# **PRELIMINARY DRAINAGE REPORT FOR THE VILLAS AT CLAREMONT RANCH**

November 2020

PUDSP-21-001

**DRAINAGE PLAN**

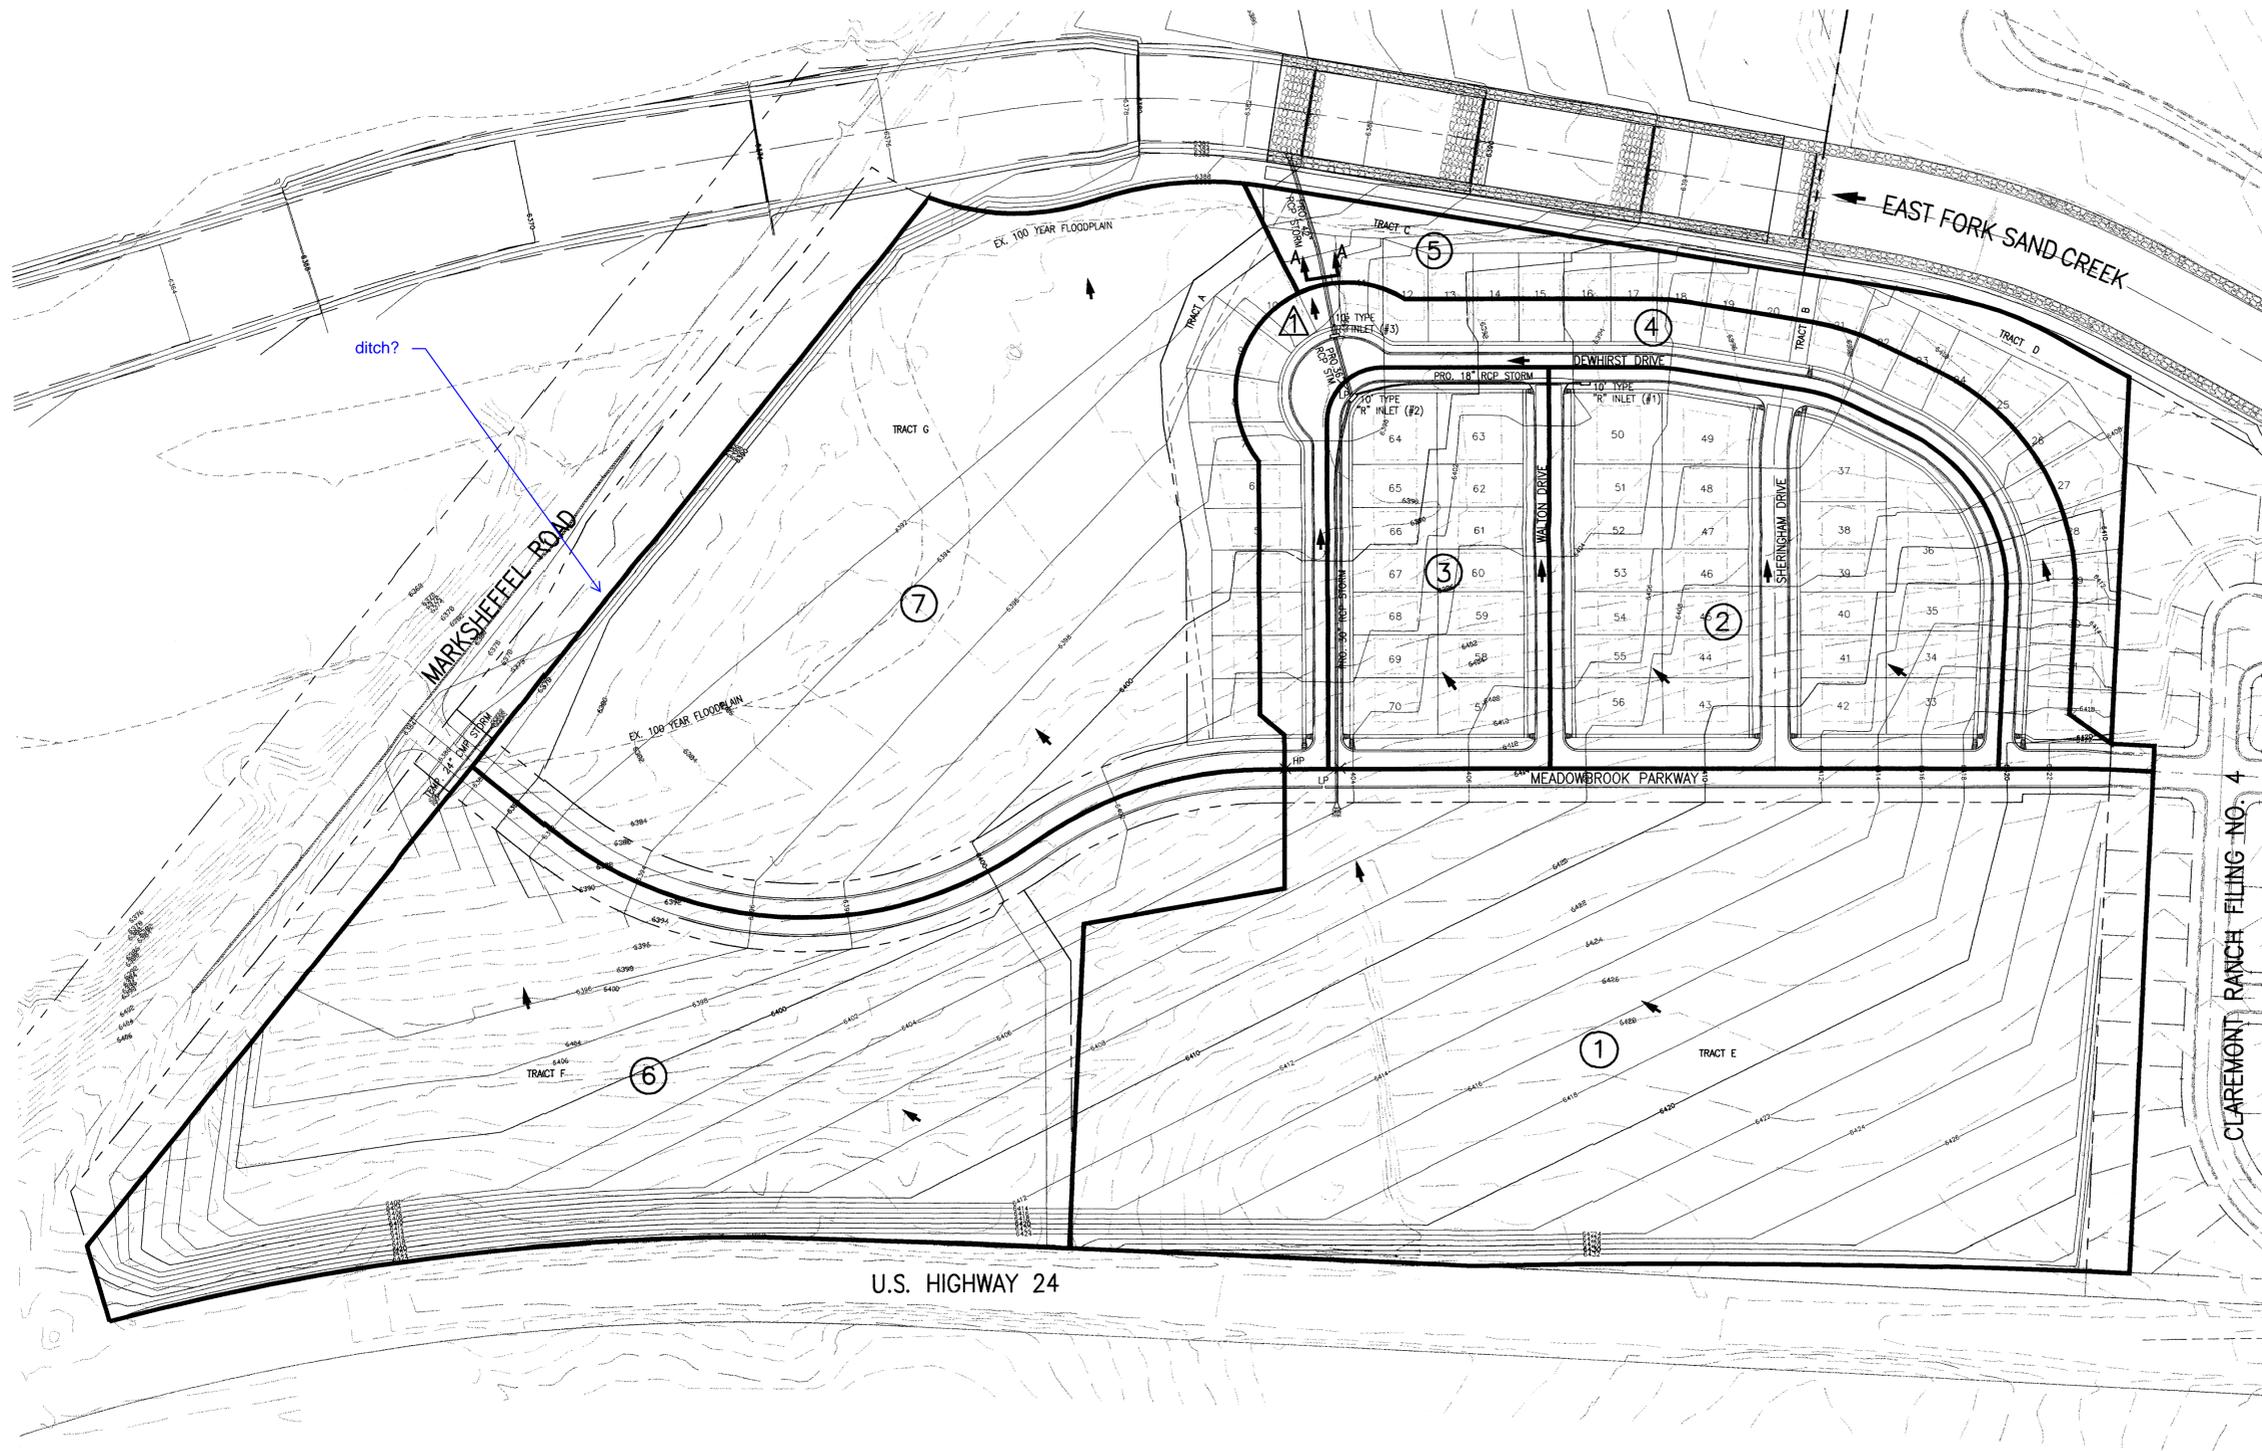
Provide a table with pond attributes (outlet and spillway elevations, water depths and volumes at WQCV, EURV, 10- and 100-year storms, etc.).

Clearly show all maintenance access roads required.

Show and label trail and proposed spillway material over the trail and to the bottom of the channel.

Show and label manhole

Show and label all easements
